World Forum for Harmonization of Vehicle Regulations**Working Party on Automated/Autonomous and Connected Vehicles****Eleventh session**

UN Regulations Nos. 13, 13-H, 139, 140 and UN GTR No. 8:**Electromechanical Brakes****Proposal for a supplement to the 11 series of amendments to
UN Regulation No. 13 (Heavy vehicle braking)****Submitted by the expert from the European Association of Automotive
Suppliers***

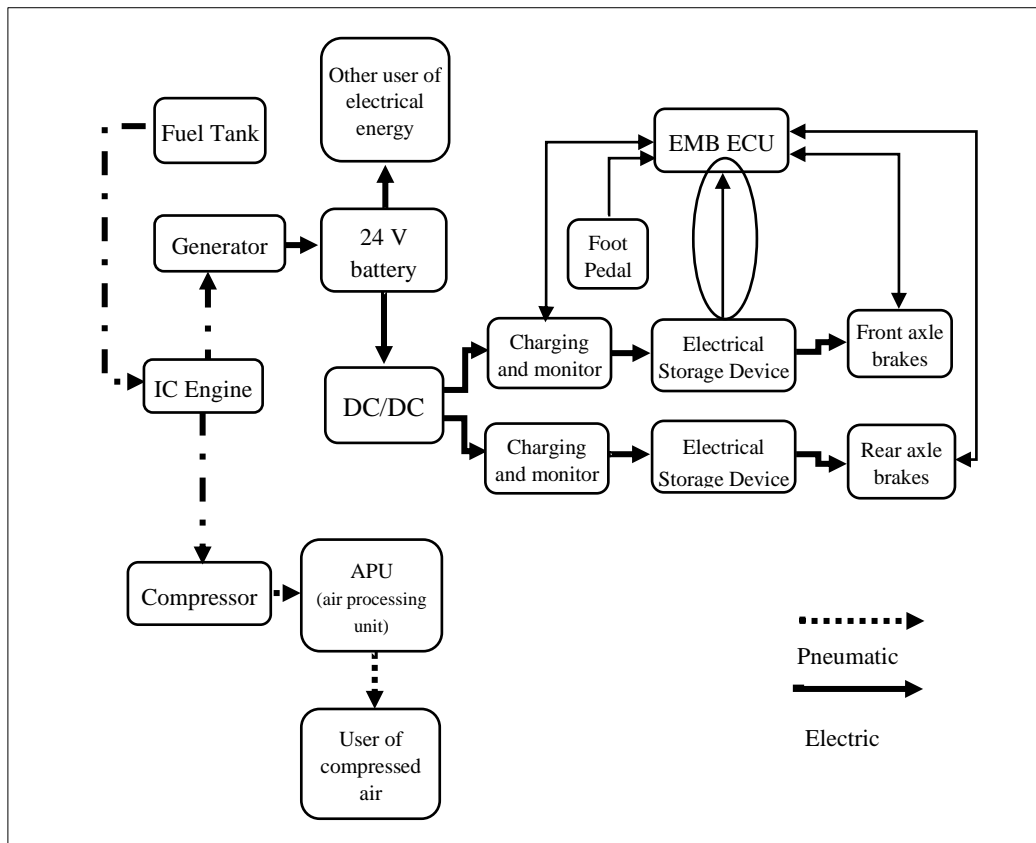
5.2.1.35.5. With an electrical energy supply feeding only the electric control transmission and in the event of a failure of that, starting from the nominal value of the energy level, the full control range of the service braking system shall be guaranteed after twenty consecutive full stroke actuations of the service braking control. During the test, the braking control shall be fully applied for 20 seconds and released for 5 seconds on each actuation. It should be understood that during the above test, sufficient energy is available in the energy transmission to ensure full actuation of the service braking system. This requirement shall not be construed as a departure from the requirements of Annex 7, Part D, paragraph 1.

41. Paragraph 5.2.1.35.5. addresses a configuration of an electro-mechanical braking system where an electrical energy storage device (e.g. battery) only supplies energy to the control transmission (but not to the electrical energy transmission as in the case with an EBS which has to comply with paragraph 5.2.1.27.5.); as an exemplary braking system see figure in paragraph 5.2.1.35.5.).

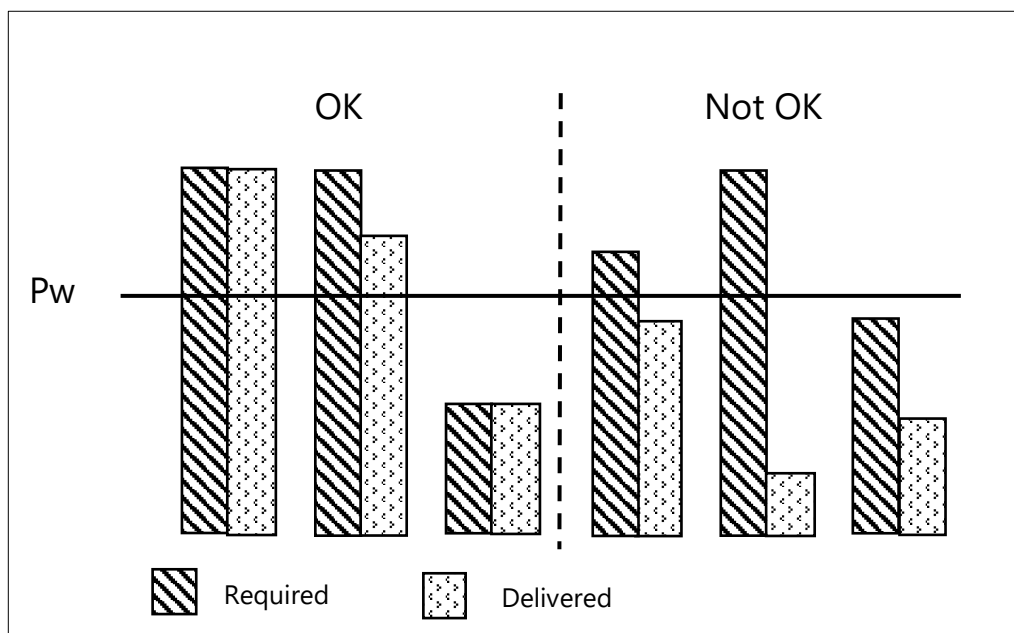
5.2.1.35.6. In the case that the electrical energy storage devices are also providing electrical energy for the electrical control transmission, the requirements of paragraph 1.2.1. of Part D of Annex 7 shall apply.

42. In contrast to paragraph 5.2.1.35.5., this requirement addresses a configuration of an electro-mechanical braking system where energy storage devices are providing electrical energy for the electrical control and electrical energy transmission; as an exemplary braking system see figure in paragraph 5.2.1.35.6.).
